Release Note

Edgecore ECW5211-L Release v3.45.0000

Document # Edgecore_ECW5211-L_v3.45.0000_1.22-1.9725

Enhancement from v3.43.11_1.9-1.9557

1.1 Port Configuration

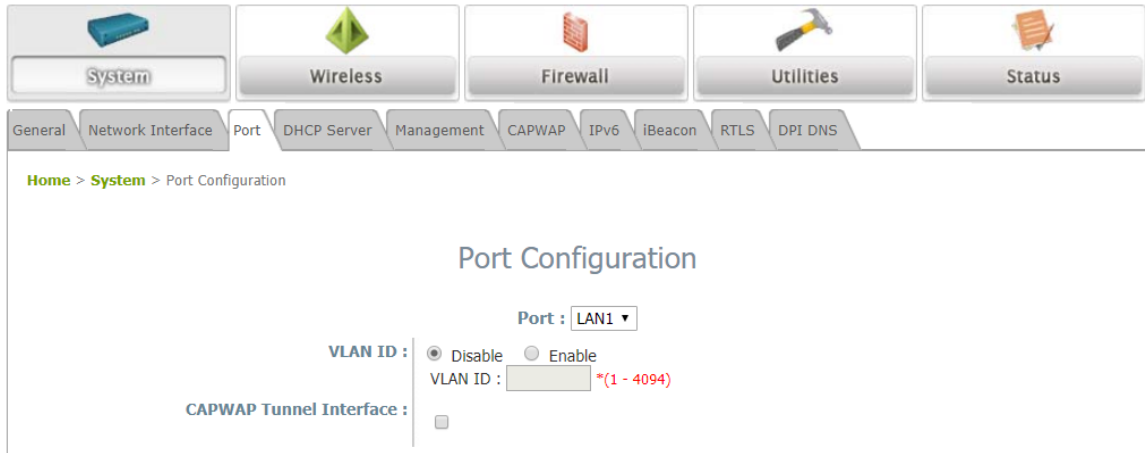
Add Port Configuration page in System for configuring the VLAN ID to specific port.

1.2 LLDP

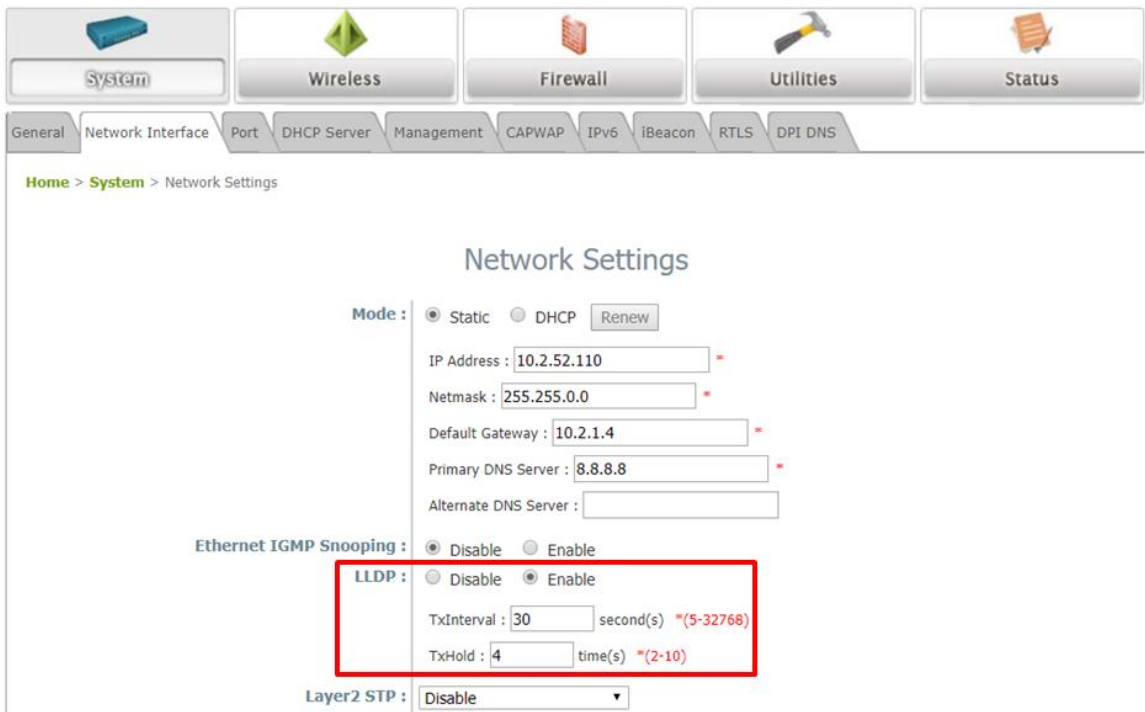
Add LLDP in Network Interface page of System.

TxInterval: Setting the interval for sending the packets.

TxHold: Setting the times of interval for sending the packets.
